City Planning Department

Memo

To: Cranston City Plan Commission
From: Joshua Berry, AICP - Senior Planner
Date: December 3, 2021
Re: “Trolley Barn Plaza” - Master Plan - Major Land Development

Owner/App: Trolley Barn Associates, LLC c/o First Hartford Realty Corp
Location: 777 Cranston Street, AP 7, Lot 1
Zone: Existing: M-2 (General Industry) – Proposed: C-5 with conditions
FLU: Existing: Special Redevelopment Area – Proposed: Highway Commercial/Services

BIKE PATH EXHIBIT FROM PROVIDENCE PLANNING DEPARTMENT

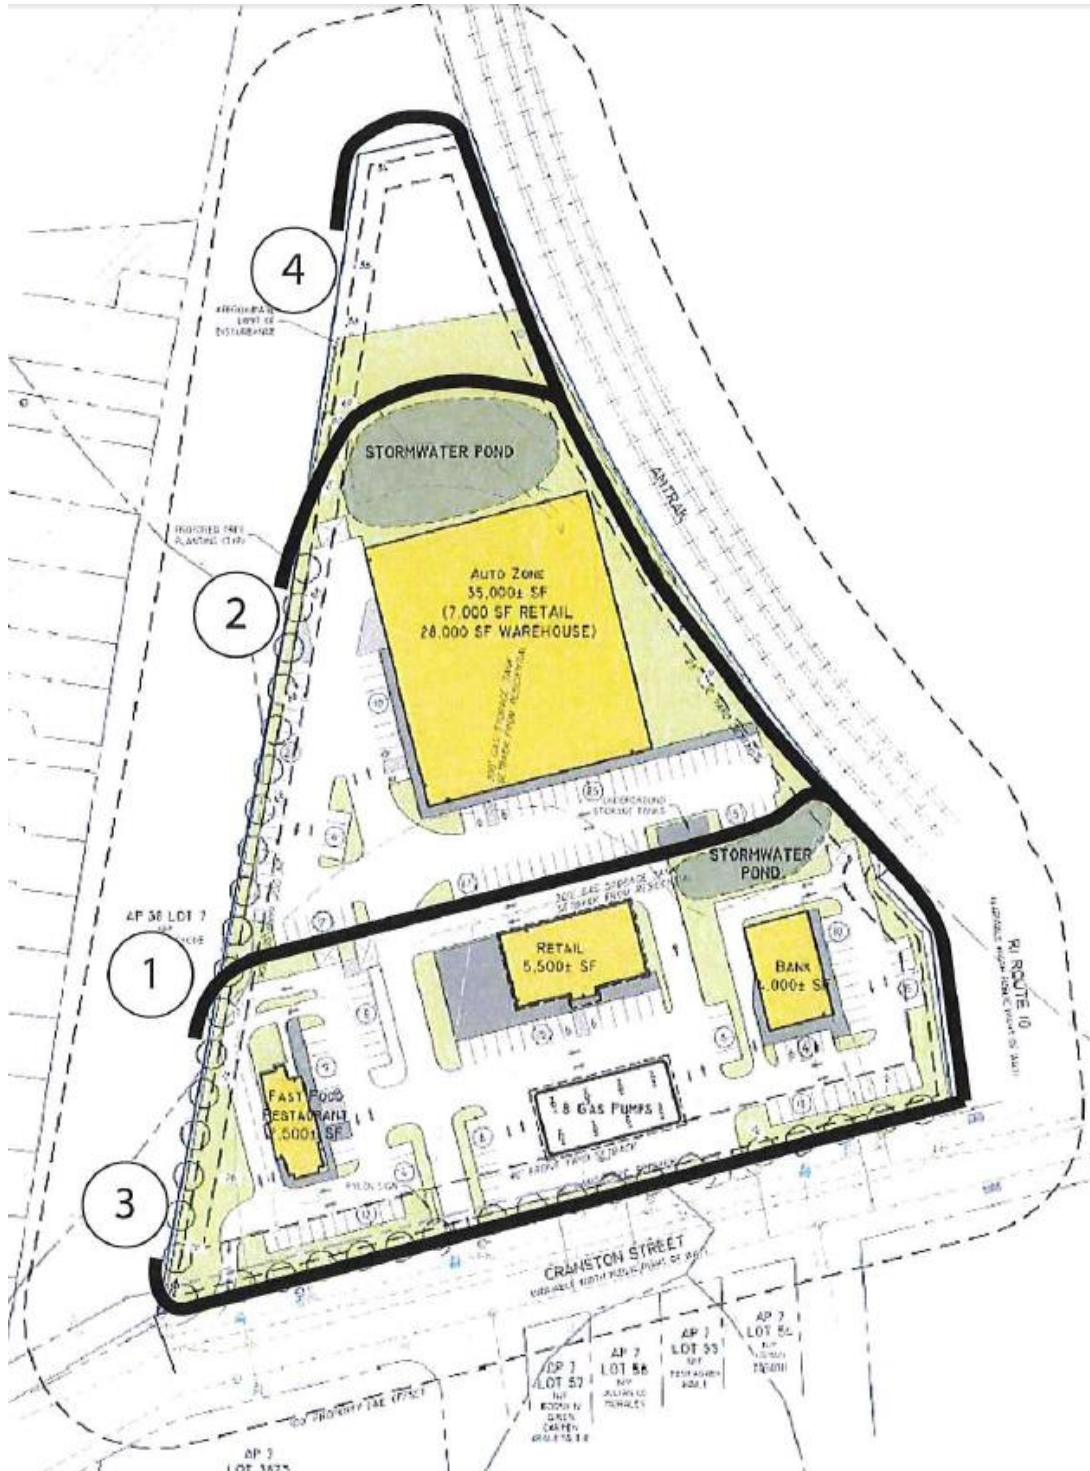
8. Providence Planning Department also conveyed that option #2 (see next page) was now considered the best of the 4 options. **The Applicant has verbally agreed to granting an**

easement for the future bike path connection equal or similar to option #2, to be determined at a later phase of this project. Staff recommends, should the Plan Commission grant Master Plan approval, that this agreement be incorporated into a condition of approval with a degree of flexibility built-in.

6. The applicant shall coordinate with the Cranston Planning Department and Providence Department of Planning and Development to connect the bike path, which may include the applicant granting an easement (roughly 15' wide) in a location similar to Route/Option #2 as identified in the letter addressed to Jason Pezzullo from Bonnie Nickerson of the Providence Department of Planning and Development, dated 10/19/21.
